# ARIZONA WATER COMPANY

Re: Letter of Intent for Construction of a Domestic Water Supply Well, Warehouse, Equipment and Material Storage, and Vehicle Parking

**RE: PZ21-00021 (CUP, DEV)– Site Plan/Design Review  
Arizona Water Company, Public Utility Facility  
135 Road Runner Dr. Sedona AZ 86336**

Figure -3 Warehouse Elevation

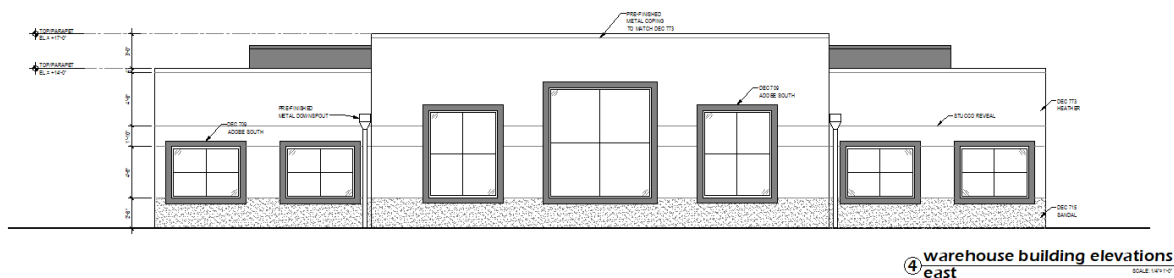
ii) Unrelieved Building Plan: No exterior wall of a building may exceed 800 square feet. The south elevation of the storage building is 1,232 square feet. Redesign to incorporate recesses/offsets to ensure no building plane is more than 800 square feet.

iv) Roofline Variation: Rooflines are limited to 50 feet in length without a visual variation. The storage building is 88 feet long without a change in roofline. See this code section for what would qualify as a roofline variation.

Response: This storage building has been separated to two individual buildings that their building planes are 650 SQ.FT. and 540 SQ.FT. respectively.

Response: This storage building has been separated to two individual buildings that their building planes, the largest building of the 2 has a 48'-0" length of roofline, all overhead bays are 2' higher than the roof line. See elevation sheets A1 and A2 indicated the elevation variation as well as A3.
